Item 5.**Section 4.55 Application: 132-138 McEvoy Street, Alexandria - D/2018/1615/D****File No.:** D/2018/1615/D**Summary****Date of Submission:** 19 May and 30 June 2021**Applicant:** Willowtree Planning**Architect:** SJB Architects**Owner:** Stormac Pty Ltd**Proposed Modification:** The subject application seeks to modify the previous consent for a 4-storey commercial building to:

Figure 11: Proposed modifications to the roof plan

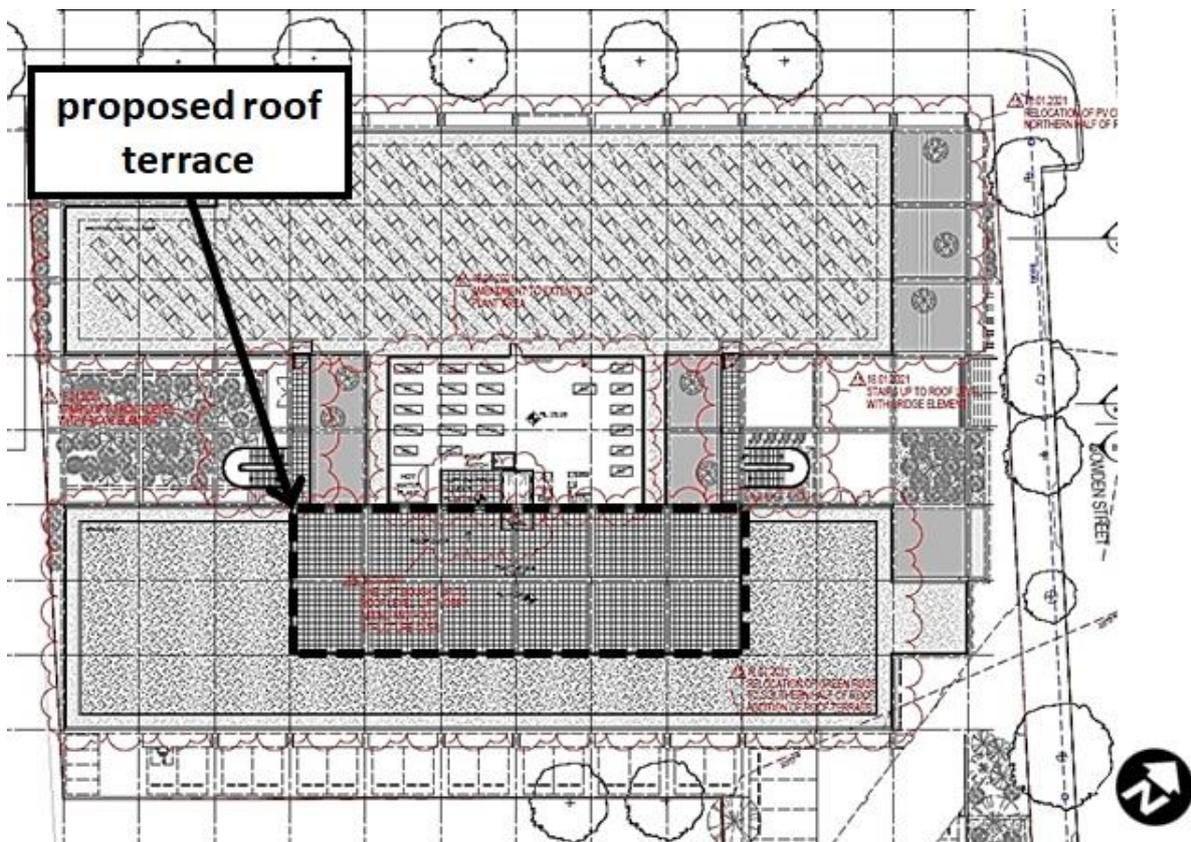
Proposed Modification	Assessment
Roof plan	
Extend the lift shaft and fire stairs to provide access to the rooftop terrace.	<p>Provision of stair and lift access to the roof will improve amenity for future intended occupants. There are no unacceptable adverse impacts to adjacent properties arising from the new roof structures.</p> <p>The proposal has merit and is supported.</p> <p>The resulting breach of the LEP building height control is discussed in the Issues section of this report below.</p>
Introduce a new lift lobby.	<p>A rooftop lift lobby is required to provide lift access to the roof and will improve amenity for future intended occupants of the building. There are no unacceptable adverse impacts to adjacent properties arising from the new lift lobby structure.</p> <p>The proposal has merit and is supported.</p> <p>The resulting breach of the LEP building height control is discussed in the Issues section of this report below.</p> <p>Implications for FSR and related development contributions are discussed in the Issues and Financial Contributions sections of this report below.</p>

Relocate solar PV cells to the northern portion of the roof.	<p>The proposed relocation maintains the quantum of solar PV as previously approved under the original consent.</p> <p>The proposal has merit and is supported.</p>
Relocate green roof to the southern portion of the roof.	<p>The proposal has merit and is supported.</p> <p>Refer to the discussion of landscape design in the Issues section of this report below.</p>
Delete a portion of the green roof and replace with a communal trafficable roof terrace.	<p>The proposal is supported in-principle.</p> <p>A condition is recommended requiring landscape design details of the trafficable rooftop terrace to be submitted to and approved by Council Officers.</p> <p>Refer to the discussion of landscape design in the Issues section of this report below.</p>
Reconfigure rooftop plant enclosure.	<p>The rooftop plant enclosure is to be reconfigured to accommodate the changes outlined above. Rooftop plant is screened and will not be visible from the public domain.</p> <p>The proposal has merit and is supported.</p>

Figure 12: Proposed modifications and subsequent breaches of the 18m height control

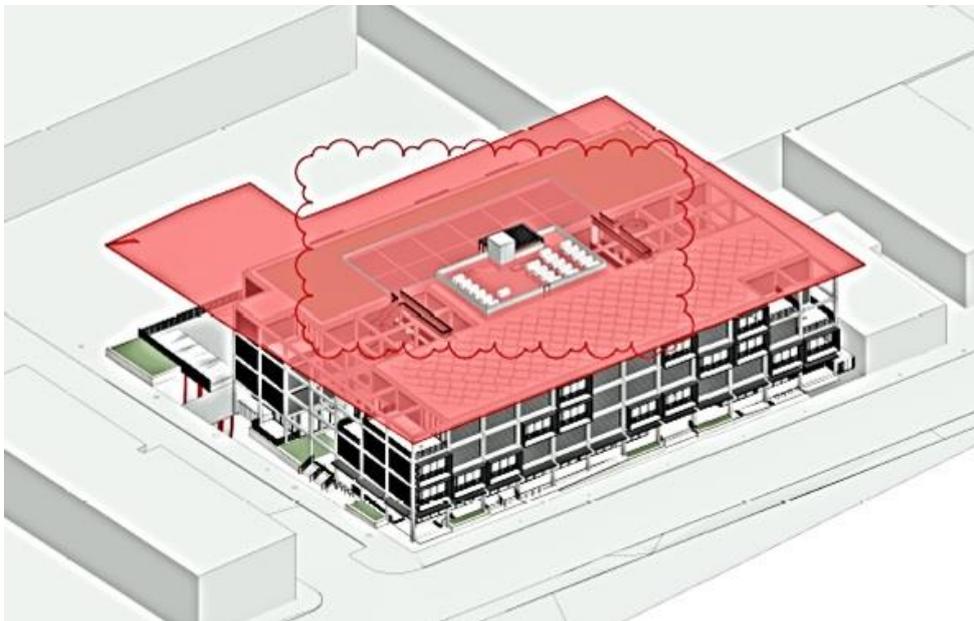
24. The previously approved development (under consent no. D/2018/1615/C) was to a maximum building height of 17.4m (RL 26.90).
25. The proposed modifications introduce several new rooftop structures such as new lift overrun, lift lobby and balustrades to the rooftop terrace. The rooftop plant enclosure has also been increased in height. All these modifications result in increases in the height of the building.
26. The proposed modifications result in a maximum building height of 21.1m (RL 30.20) to the top of the lift overrun and a breach of the 18m LEP maximum permitted building height control as shown in Figure 12 below.

27. The proposed breaches of the height control are centrally located within the roof plan and do not significantly increase the bulk and scale of the building. As noted below, there are no unacceptable adverse overshadowing impacts arising from the proposed modifications.

28. The requirement to justify departures to development standards under LEP clause 4.6 only applies when development consent is granted, not when a modification application is made. Subsequently, clause 4.6 does not apply to section 4.55 modification applications.
29. For these reasons, the proposed increase in the height of the building and the 3.1m breach or 17% variation to the 18m LEP height control, are supported.

Figure 13: Proposed roof terrace lacks shading, furniture or facilities

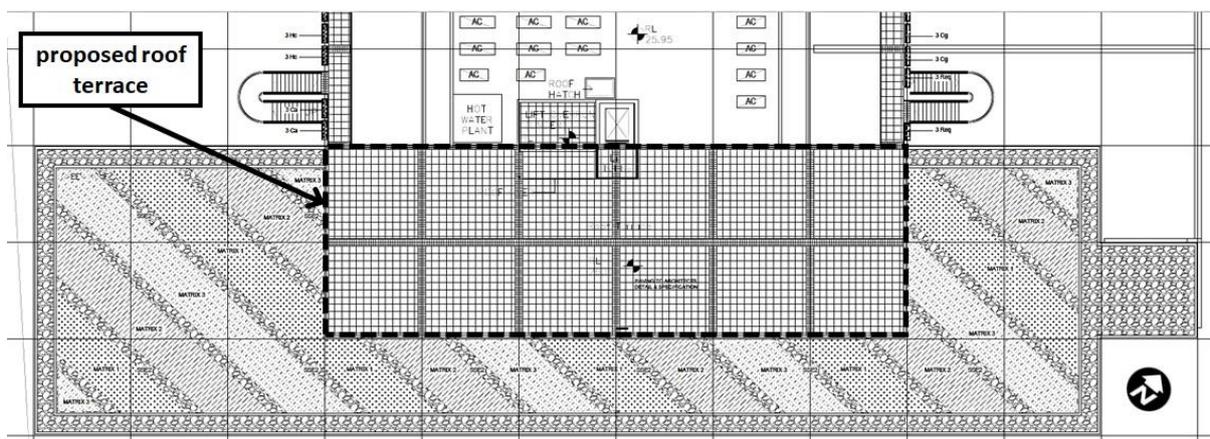
35. As noted in the Relevant History section of this report above, Council Officers raised concerns about lack of a suitable detailed design for the expansive (432sqm) roof terrace. It is unshaded and unprotected from the weather. As shown in Figure 13 below, no design of shading, facilities or furniture - has been submitted for the roof terrace space. For this reason, the rooftop terrace space would be unusable during the hotter months of the year and during inclement weather.

36. It is recommended that condition (75) Landscaping of the Site is modified - as shown below - to require a detailed landscape design for the rooftop terrace to be submitted to and approved by Council Officers, prior to the issue of any amended Construction Certificate for the development. This condition allows for the landscape design details to incorporate shade structures and the like up to a maximum height of approximately 19.6m (RL 28.70).

- (xi) ***The detailed design of the accessible rooftop terrace approved by modification D/2018/1615/D. Design details must demonstrate that the rooftop terrace can be utilised as a flexible and usable space with a good level of fixed amenity, including (but not limited to) seats, garden beds and weather protection. The design should incorporate at least three small canopy trees in planters of a minimum 1m soil depth, with volumes in accordance with the Sydney Landscape Code Vol. 2. Sectional details through planters should be provided, demonstrating the planter build-up, drainage and depth. Confirmation from a structural engineer is also required to ensure that the roof terrace has the capacity to support all elements. New shade structures and other rooftop structures incorporated into the detailed design must be no greater than approximately 19.6m in height (RL 28.70).***
